CITY OF ALBUQUERQUE
DEPARTMENT OF AVIATION
PLANS FOR CONSTRUCTION OF

DOUBLE EAGLE II AIRPORT
WATER PUMPING FACILITIES

PROJECT NO. 3667

NOTE: AS-BUILT CHANGES ON THESE PLANS WERE DRAFTED BY BOHANNAN-HUSTON, INC. FROM MARK-UPS PROVIDED BY THE CITY OF ALBUQUERQUE.

WELL PUMP INTERLOCK CONTROL DIAGRAM

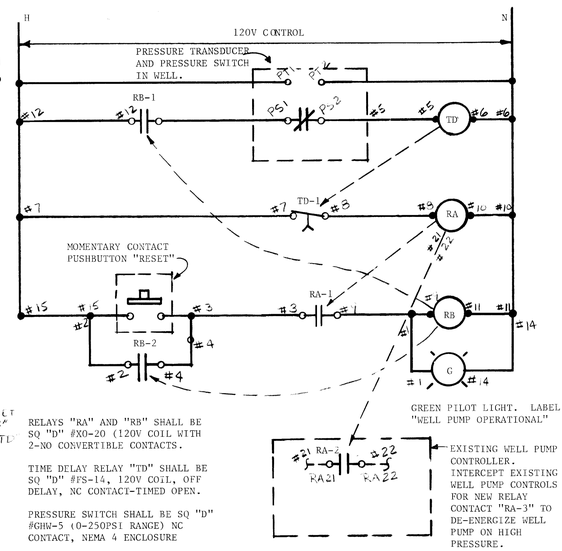
THE EXISTING WELL PUMP WILL HAVE A NEW PRESSURE SWITCH AND PRESSURE TRANSDUCER INSTALLED AT THE WELL PUMP. THE FUNCTION OF THE NEW PRESSURE SWITCH AND PRESSURE TRANSDUCER IS TO DE-ENERGIZING THE WELL PUMP, SHOULD THE PUMP PRESSURE EXCEED ~~220~~ 175 PSI FOR A PERIOD OF ~~5 MINUTES~~ 3 SECONDS (FIELD ADJUSTABLE) ~~OR MORE.~~
